# Overhead Bridge – Railway Crossing at Taxila

On Sarai Kala & Haripur Road

General View of the Taxila Overpass Bridge

NTRC-250

Figure 2. – Cracks in deck slab – view from ground level.

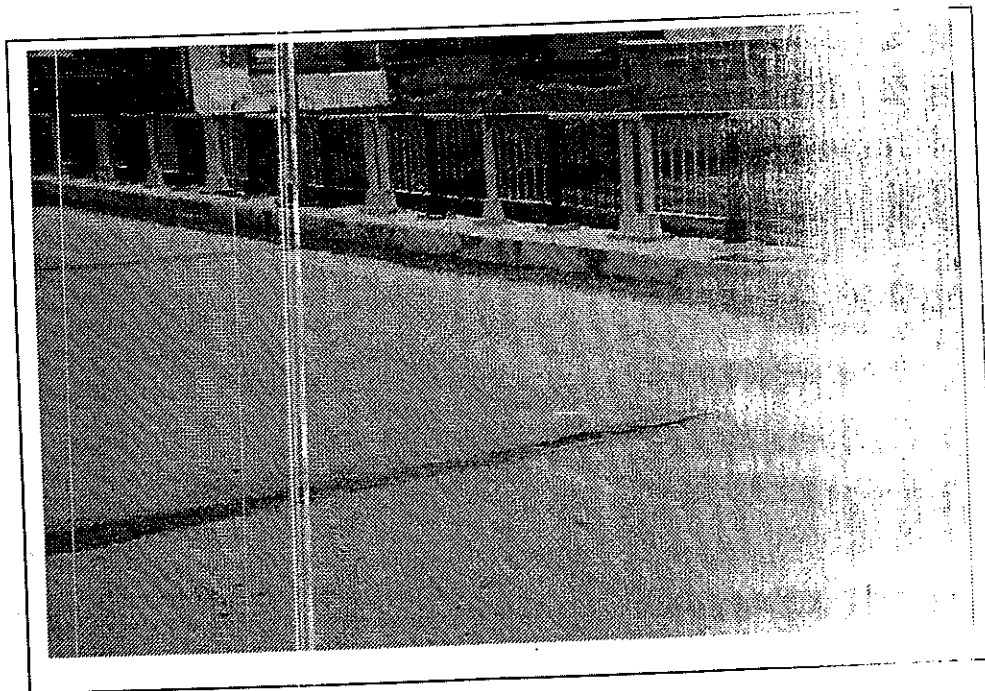
cracking at some locations. Figure 2. – shows cracks in deck slab. This view was taken from ground looking up. There is an indication of water leakage through the cracks. It was mentioned that a portion of the deck fell down and was replaced. Consequently some areas of the slab appeared to have been subsequently repaired. Cores were taken from certain visibly weaker areas of the slab. It would be interesting to see these cores as well as the results of any tests done on them.

- A 6000 psi @ 28 days concrete seems adequate for the required design strength. However, the quality of workmanship of the cast-in-place concrete appears to be questionable. It is suggested therefore that random core samples be taken and tested to determine the matrix and strength of the concrete in the deck slab. This would be the first measure to determine what remedial action if warranted should be recommended.  
Also, the actual location and the amount of reinforcing bars should be verified by non-destructive means. This is to ensure that their placement was done in accordance with the design drawings.

Figure 7. – A view from the bridge – the busiest part of the town

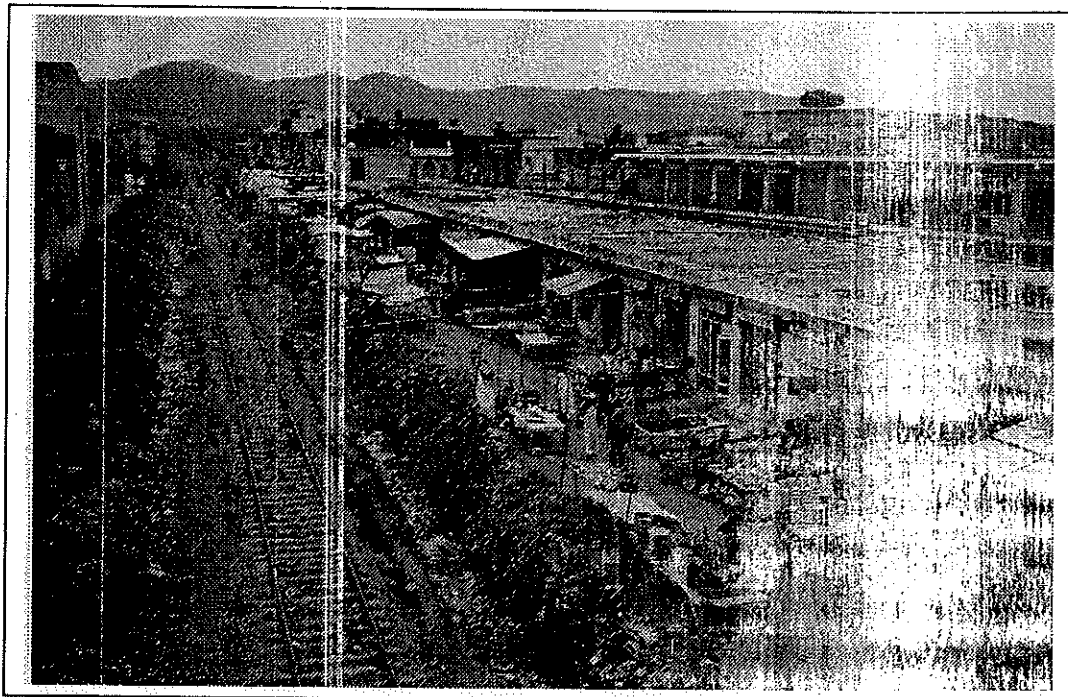
8. **Crossing Length:** For a mere railroad crossing, for an onlooker this structure seems unusually long. Understandably ramps are intended to provide a 3% grade. However, the trucks operate over the road at a reduced speed. A few trucks were seen using the service roads below on both sides of the structure. The structure is also dividing this quarter of the town into two whereby certain streets are blocked permanently by the structure. This structure could have been built shorter to avoid or minimize the above-mentioned issues as well as to save costs. This overhead structure could have been located at a less busy part of the town to prevent blockage of the street in the middle of the town. Figure 7. – shows a view from the bridge – the busiest part of the town
